## **AMENDMENTS TO THE FIGURES**

The following corrections to the drawings have been made. Red-lined versions of the drawings and replacement pages are included herewith. Applicant respectfully requests acceptance of the amended drawings.

**FIG. 5**

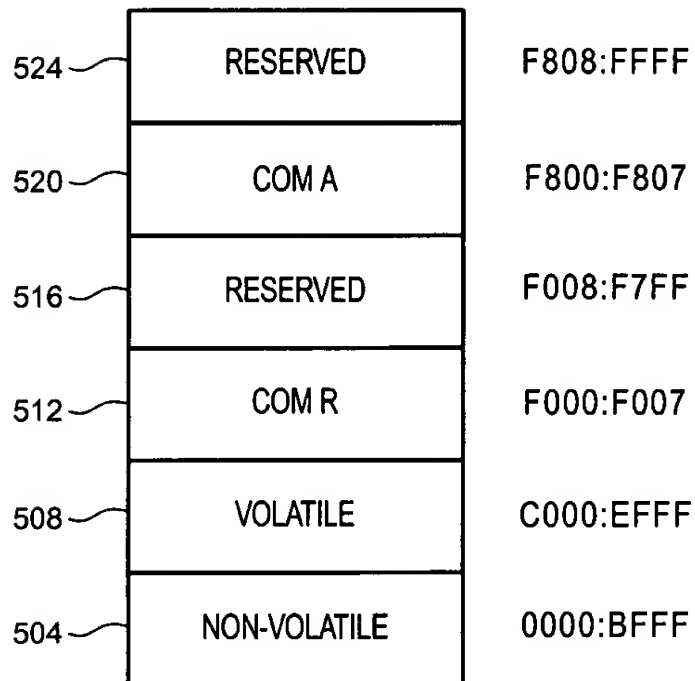
**Figure 5** – The address “F000-F00F” for COM R (element 512) has been corrected to read “F000:F007”.

FIG. 8

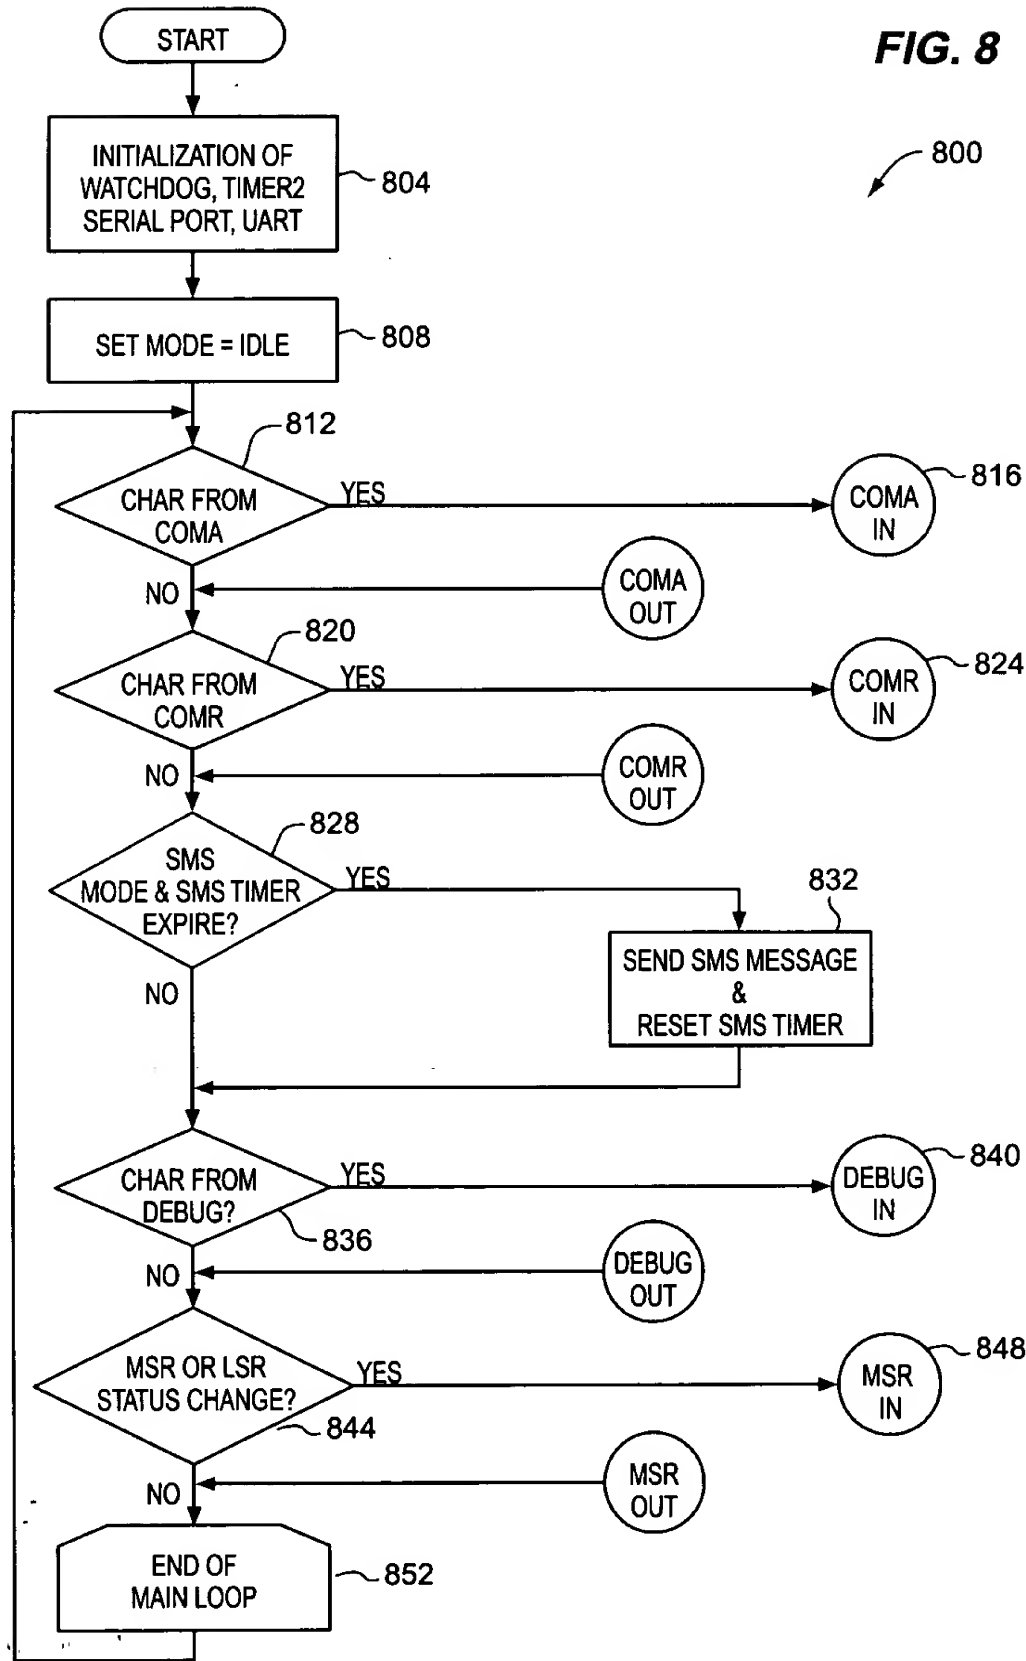
**Figure 8** – The missing element numbers 844 and 852 have been added. Element 848 has been corrected to read “MSR IN”, rather than “DEBUG IN”.

FIG. 9

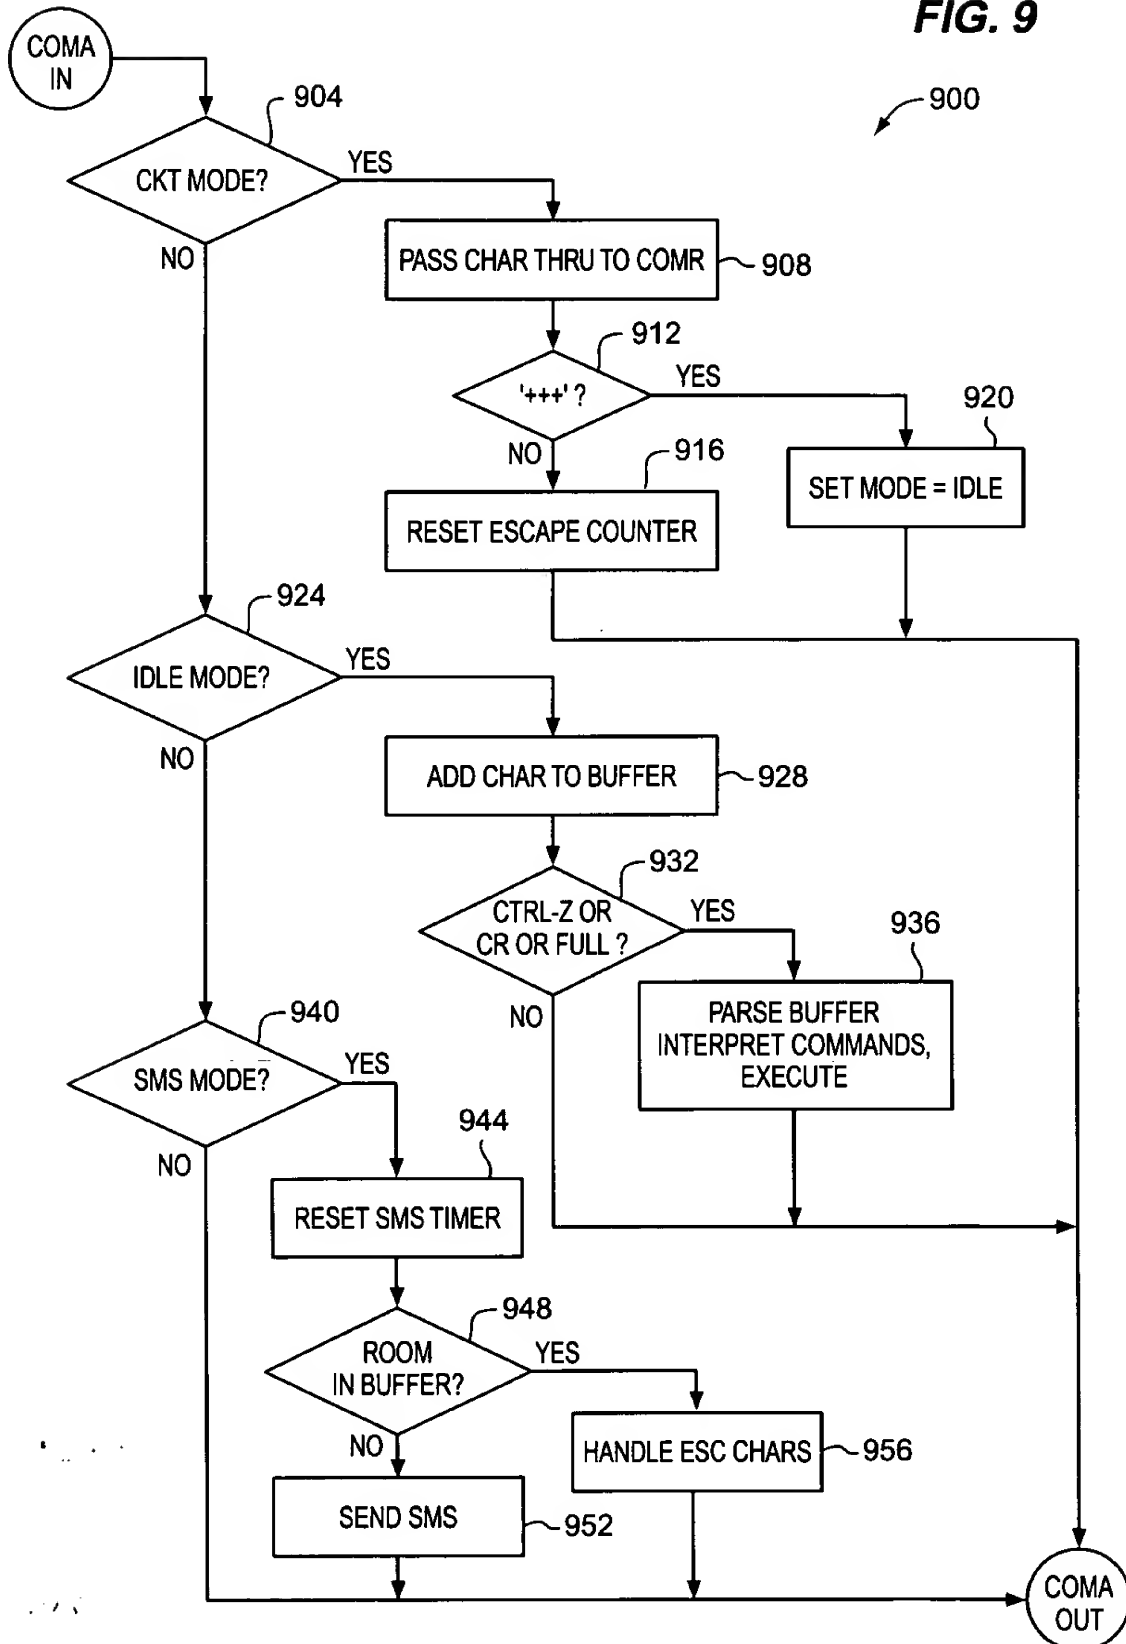
**Figure 9** – The missing element number 916 has been added.

**FIG. 11**

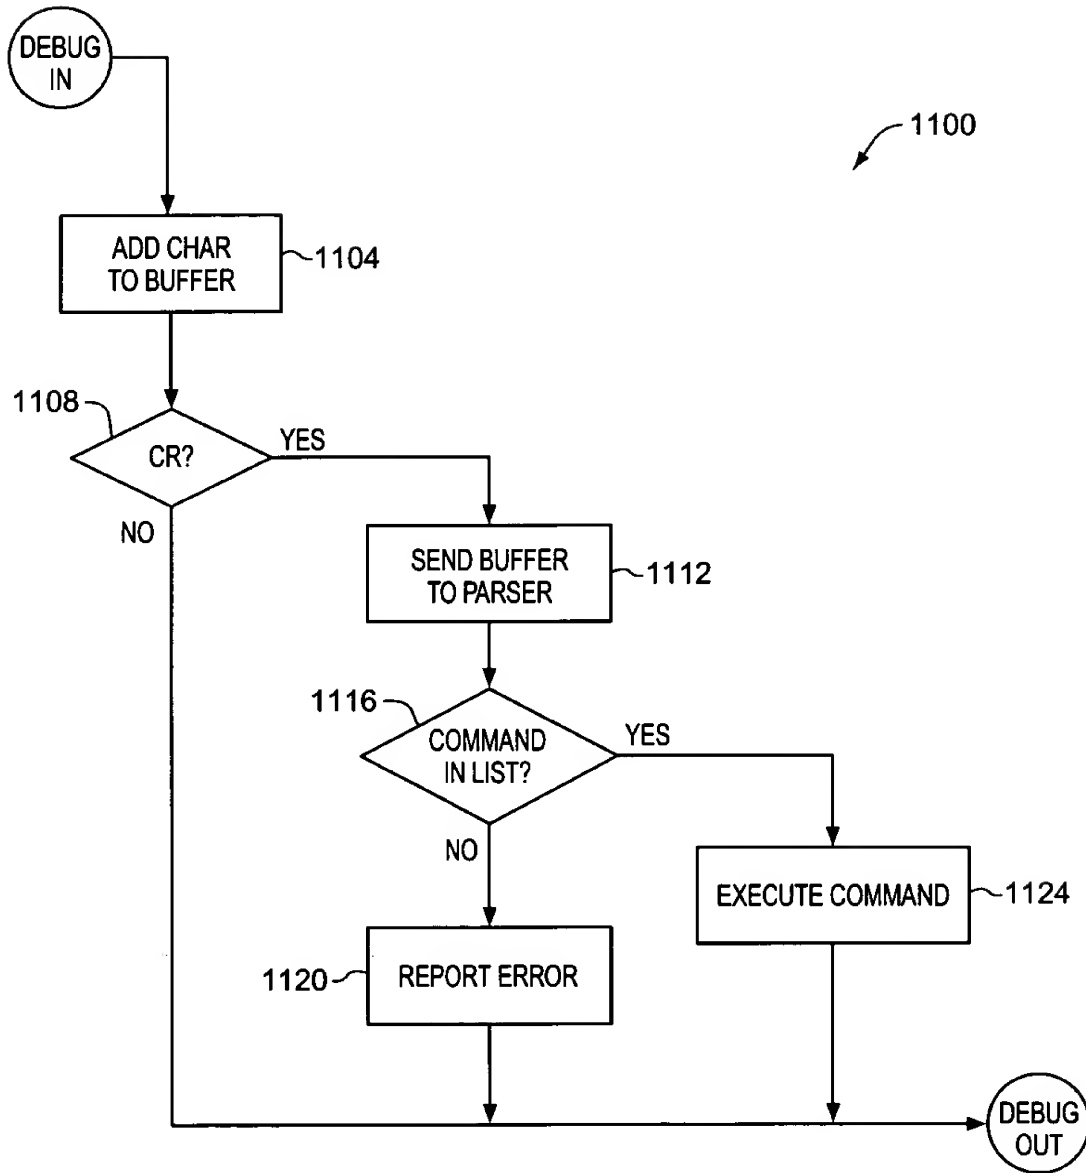
**Figure 11** – Element 1120 has been corrected to read “REPORT ERROR”, rather than “RECORD ERROR”.

**FIG. 13C**

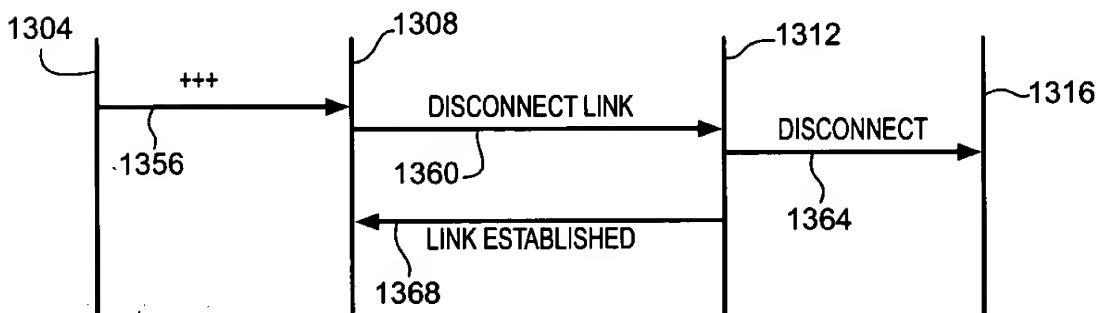
**Figure 13C** – The designation for element 1356 has been corrected to be “+++”, rather than “+++ATH”.

**FIG. 15c**

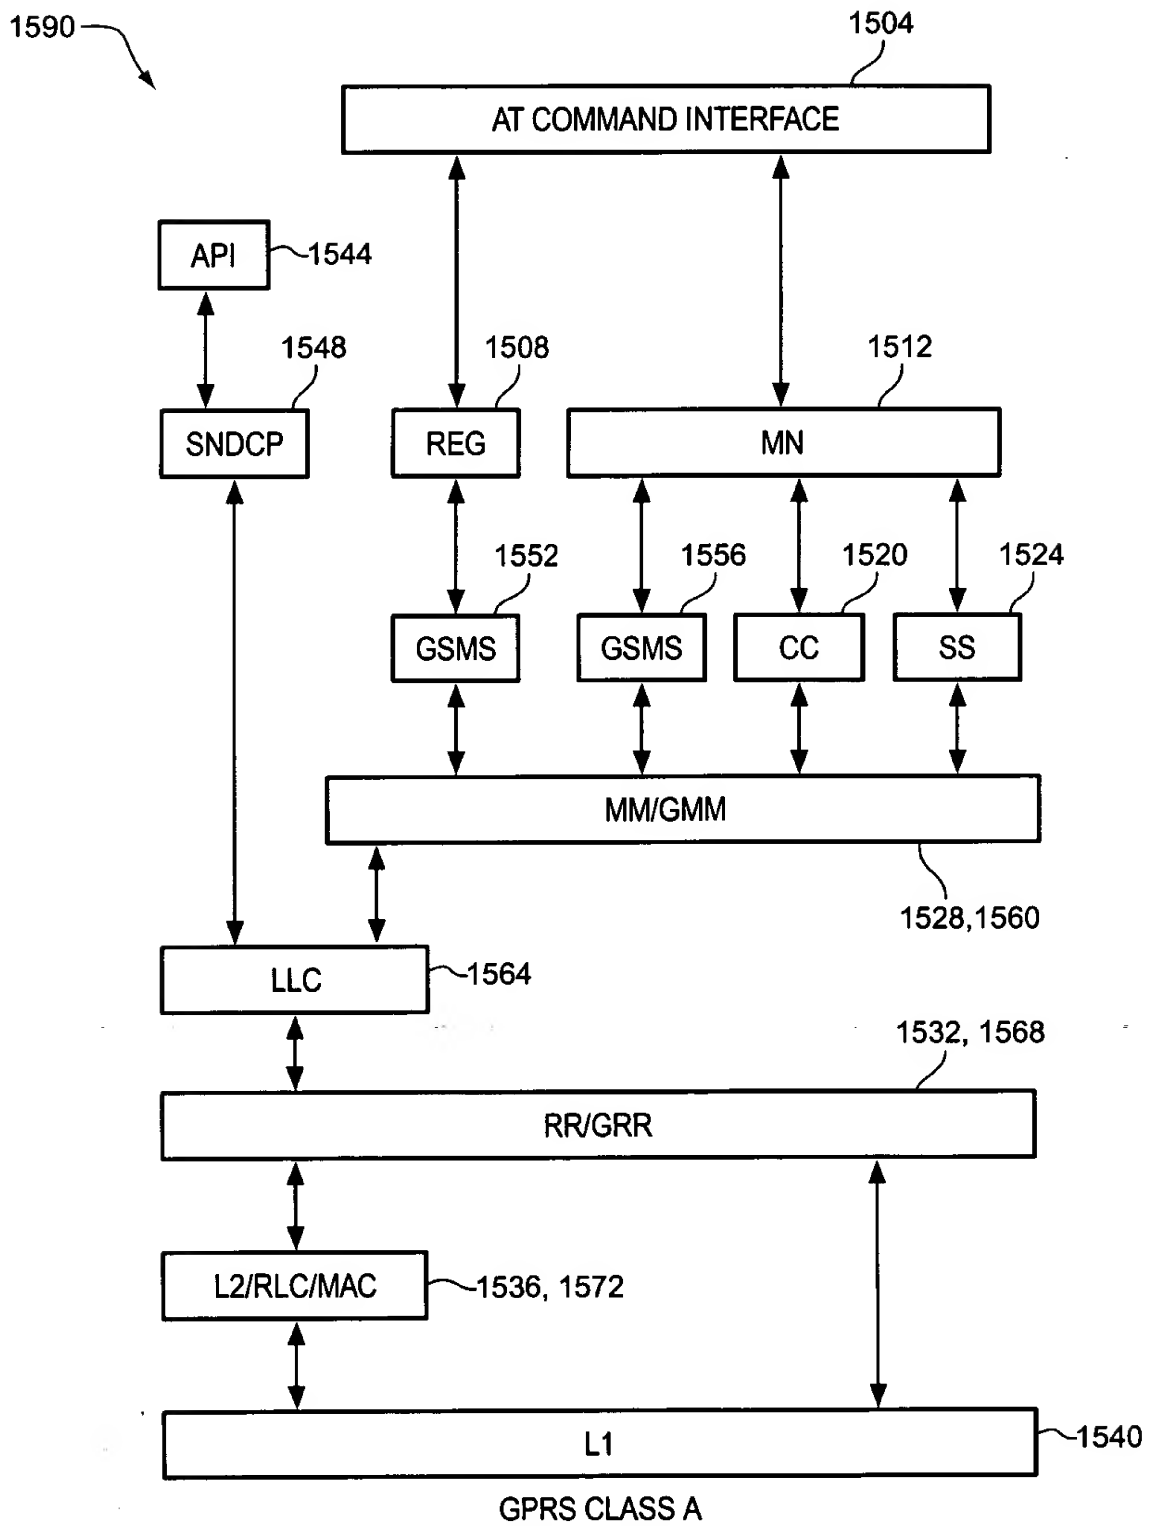
**Figure 15C** – The element designated as “RR/GRR” has been corrected to have element number 1568, rather than 1588.
